# INSPECTOR GENERAL

JULY 18, 2013

## Compliance with Electrical and Fire Protection Standards of U.S. Controlled and Occupied Facilities in Afghanistan

Figure 1. Reverse Polarity and No Grounding - Chaplain's Office Building Kitchen Area

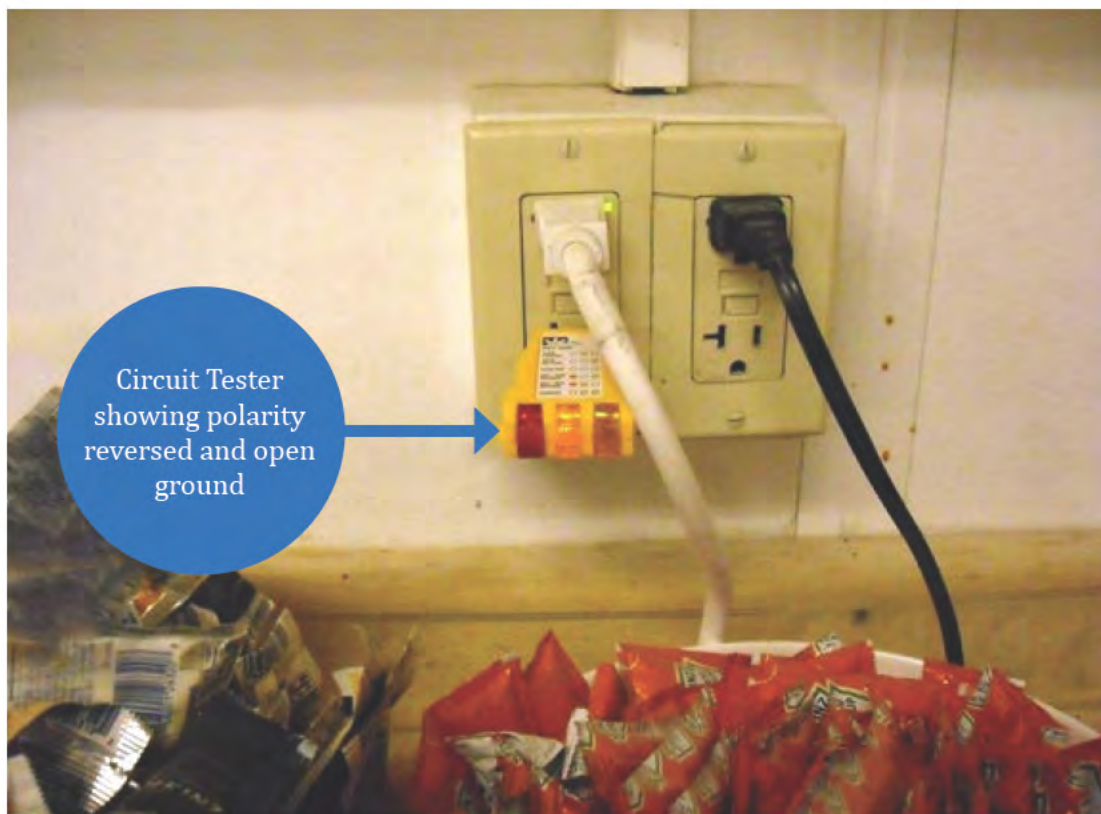
KAF-EL-120426-026
